# 95 Fawcett

Special Permit Submission [SP Permit #309]

Revised Submission Package to Original January 20, 2016 Full Submission  
Cambridge Planning Board & Cambridge Community Development Department

## Revised Architectural Plans and Elevations:

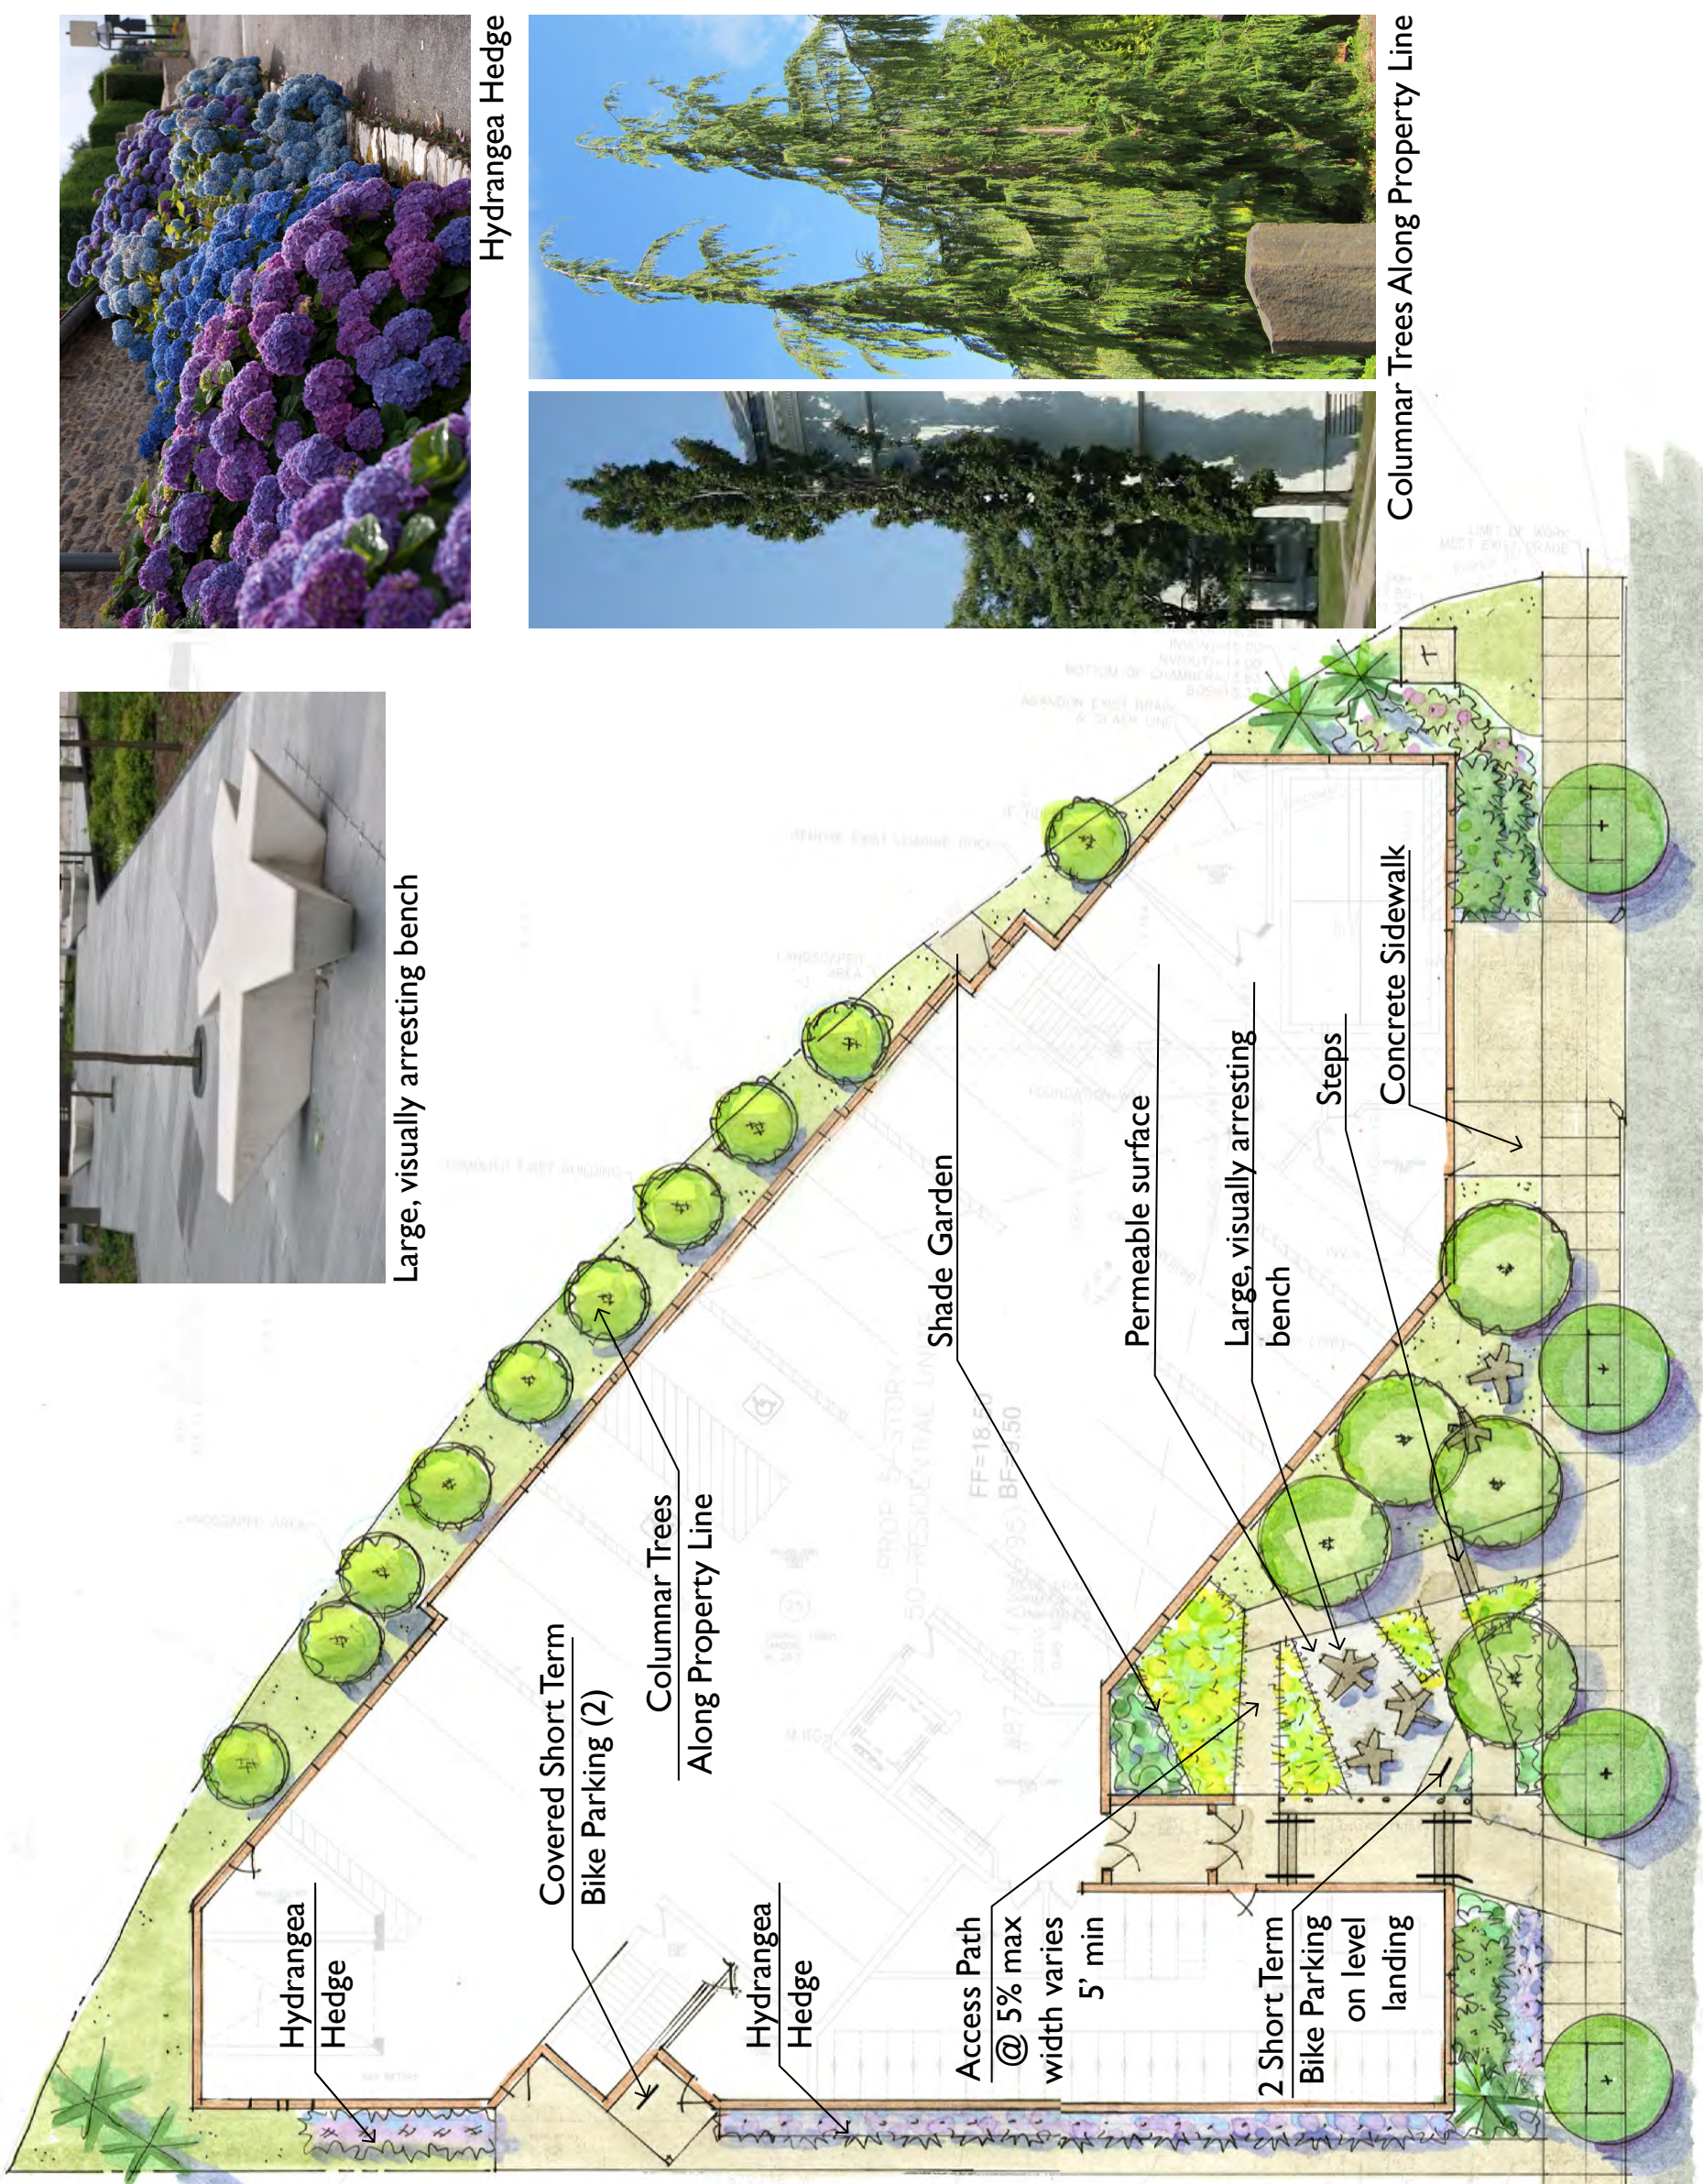
Sheet #	Drawing Name
<b>Landscape Drawings - [Prepared by Blair Hines Associates, Inc.]</b>	
Sheet 1 of 4	Proposed Site Plan Layout <ul style="list-style-type: none"> <li>Updated to show covered locations of short term bicycle parking distributed to each of the main building entries, final locations coordinated with the City's Transportation Department</li> </ul>

**6** ROOF FLOOR PLAN  
SCALE: 1/16" = 1'-0"

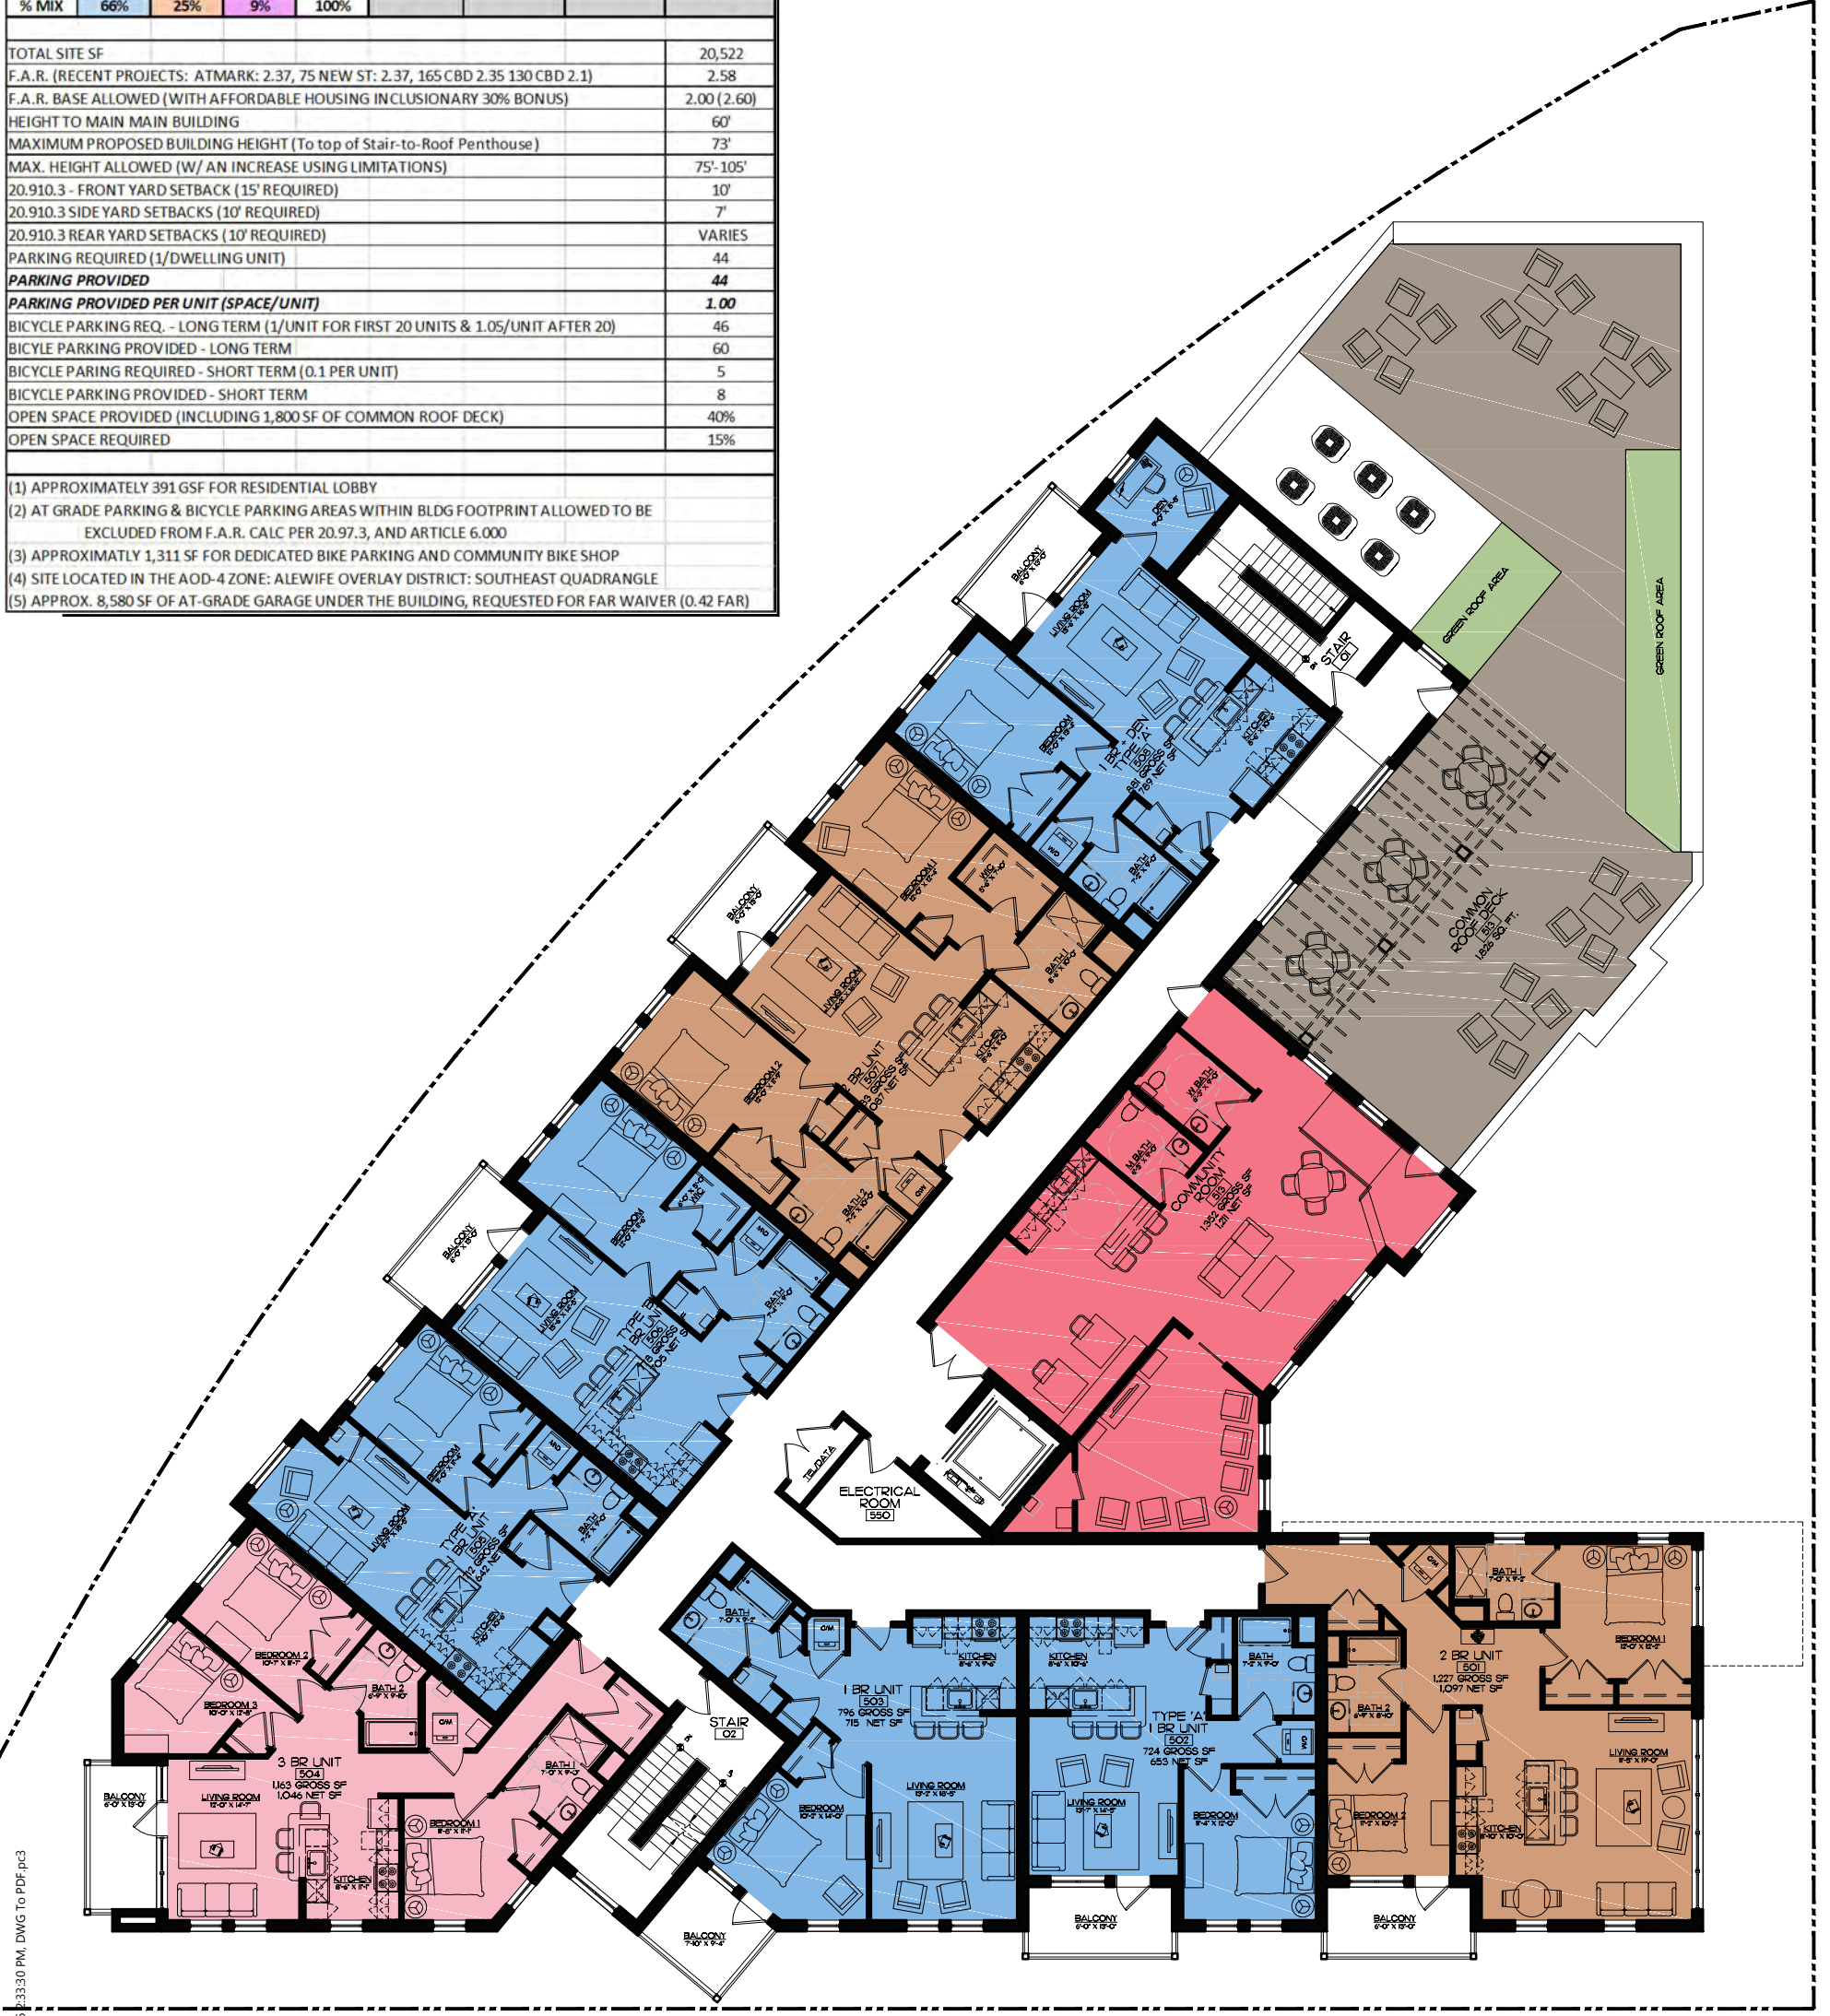
- A1.5 Fifth Floor Plan
- *Unrevised, but kept in submission for a complete drawing package.*
- A1.6 Roof Level Floor Plan
- *Updated rooftop mechanical equipment layout including Rooftop Unit for common areas shown. Please note equipment not blocked by the building parapets are screened with partition screening systems.*

**A3.4**

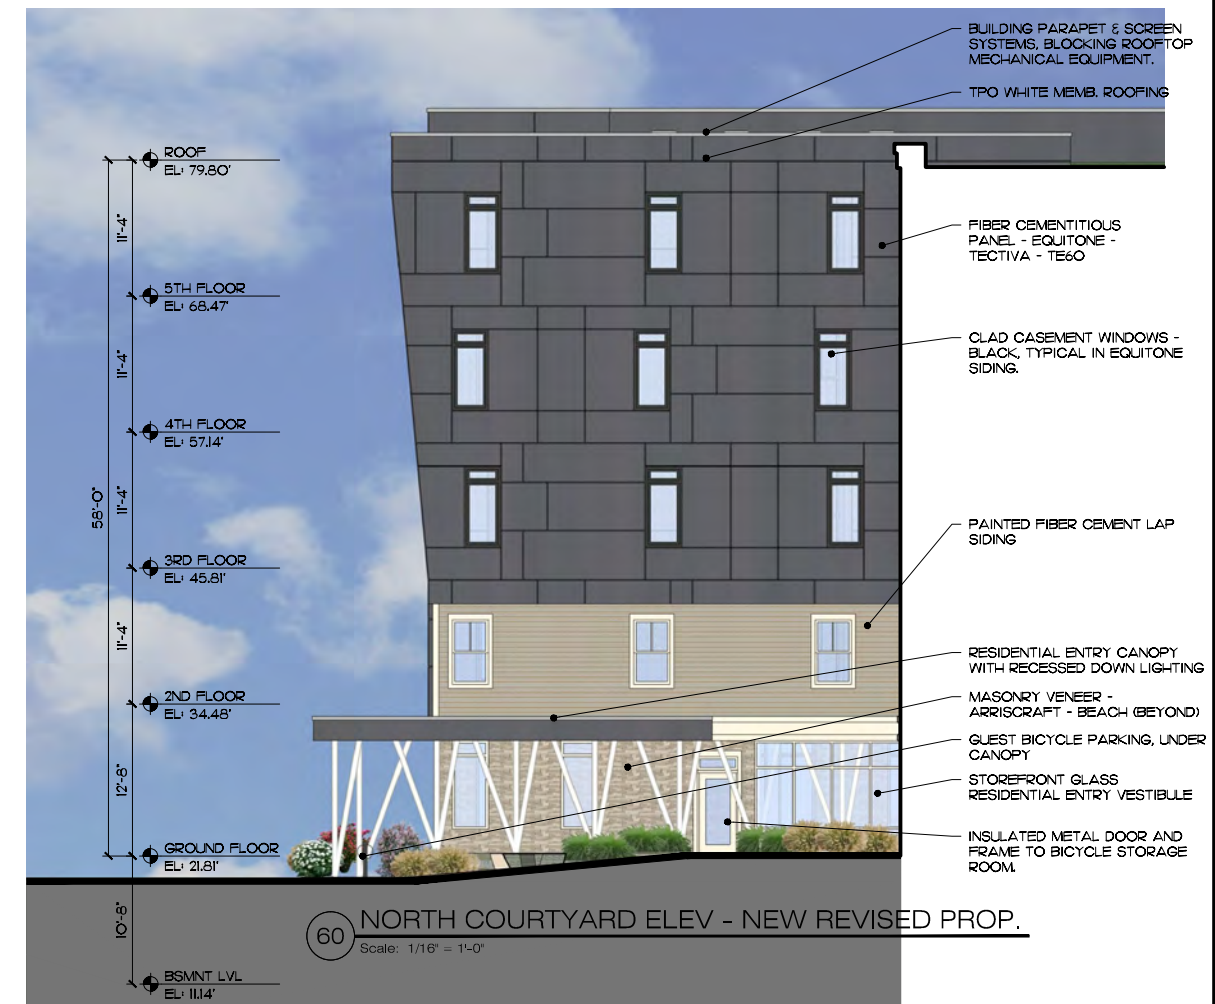
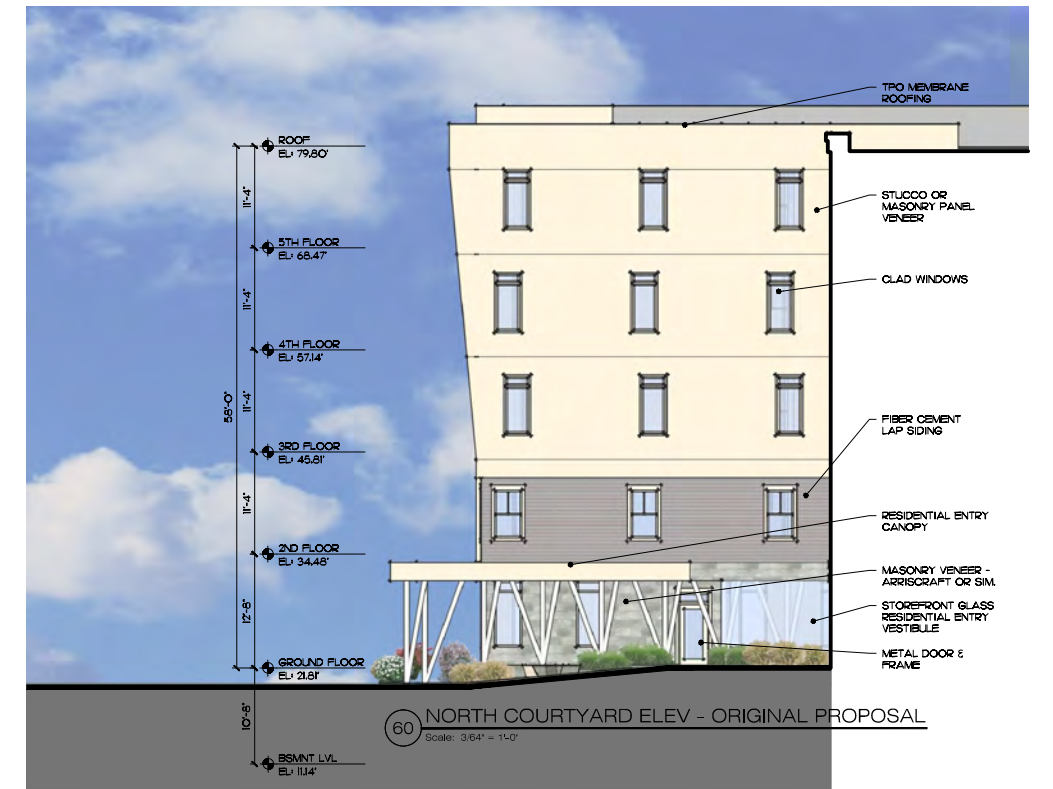
- *Transformer and trans-closure cabinet has been sized and its location has been called out.*
- A3.4 Building Elevations
- *Updated building design calling out building materials and façade treatments, shadowing included to show depth of façade elements (previous design included for comparison)*

95 FAWCETT ST. CAMBRIDGE, MA **A3.10**

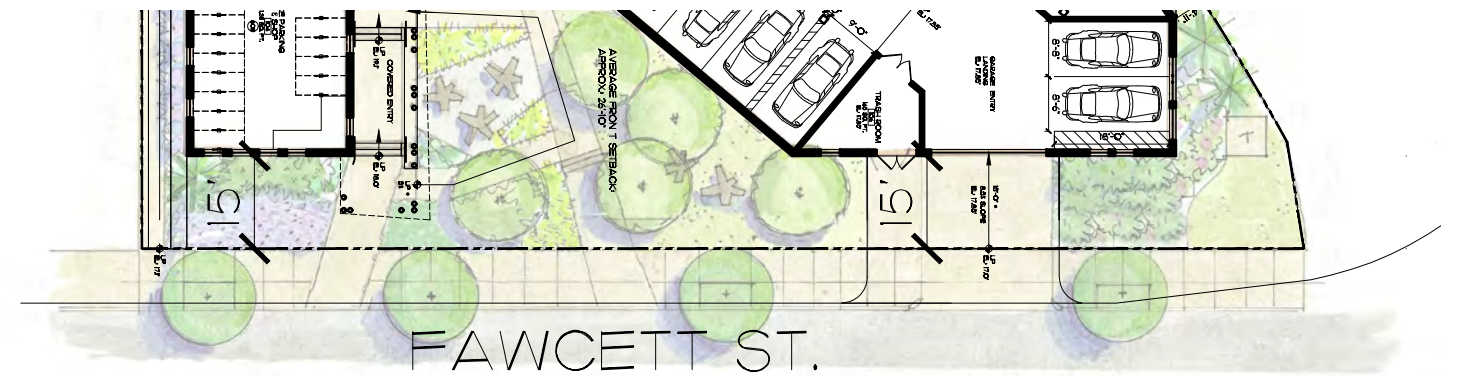
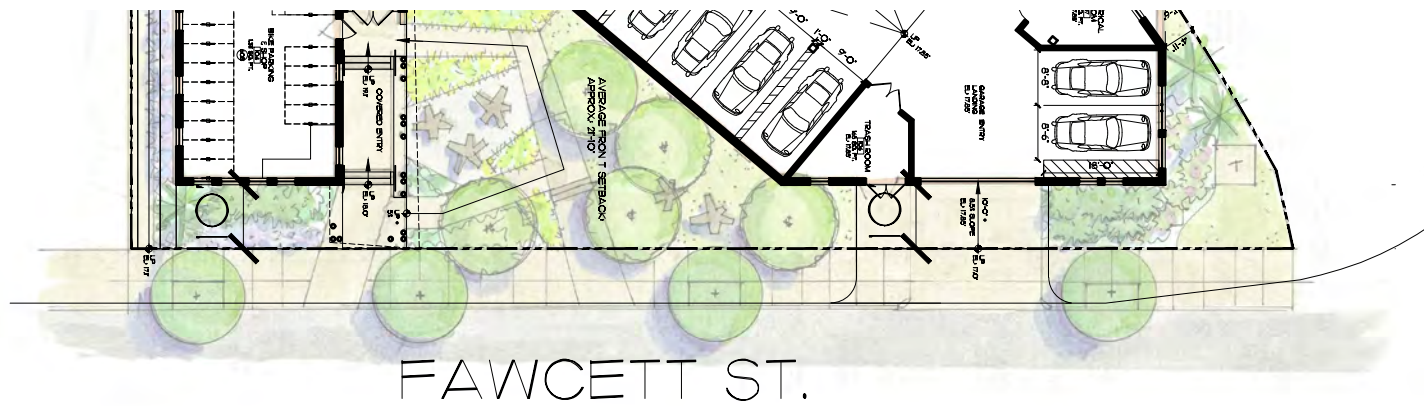
- A3.7 Building Perspectives and Images II
- *Updated building design comparisons.*
- A3.8A thru D Building and its Site Bird's Eye Perspectives
- *A series of new drawings of bird's eye perspectives of the proposed project sitting in its site for more context and neighborhood information*
- A3.9 Courtyard Pocket Park Perspectives
- *New drawing with a couple of pedestrian level perspectives of the Building entrance and courtyard pocket park shown.*
- A3.10 Bldg Comparison demonstrating difference between 10' & 15' Setback
- *A plan and perspective study demonstrating the negligible visual impact of a 10 foot (proposed) versus 15 foot (required) building front yard setback.*
